Tracer™ AH.540 and AH.541 Replacement

BRD02962 Replaces BRD02814

Literature Order Number	PART-SVN84A-EN
File Number	SV-SP-Controls-PART-SVN84A-EN-0404
Supersedes	New
Stocking Location	Electronic Only

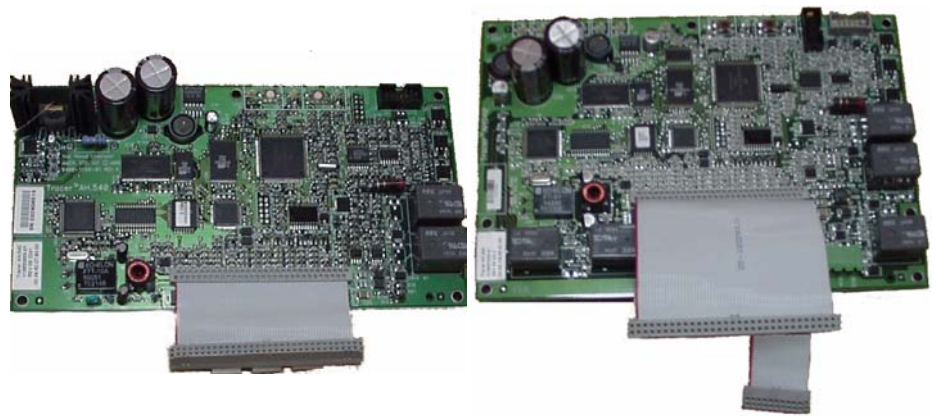
When replacing a version 1.0 or 1.5 board (BRD02814, X13650859-01 or equivalent), you will notice that this new board (BRD02962) is physically different. It is functionally the same. The boards use the same mounting holes and connections. The new one has two connectors; both should be connected to the termination board. This board has additional outputs that are not used if you are replacing a version 1.0/1.5 board.

The new board will be recognized by the Rover Service Tool as a version 2 device. Setup and configuration will be similar to that of the old board. If Rover does not recognize this board, you will need to obtain Rover V5.0 with service pack 2 or higher. Also, version 1 RCF (Rover Configuration File) is not compatible with the version 2 hardware - the board will have to be configured using the Rover configuration screen.
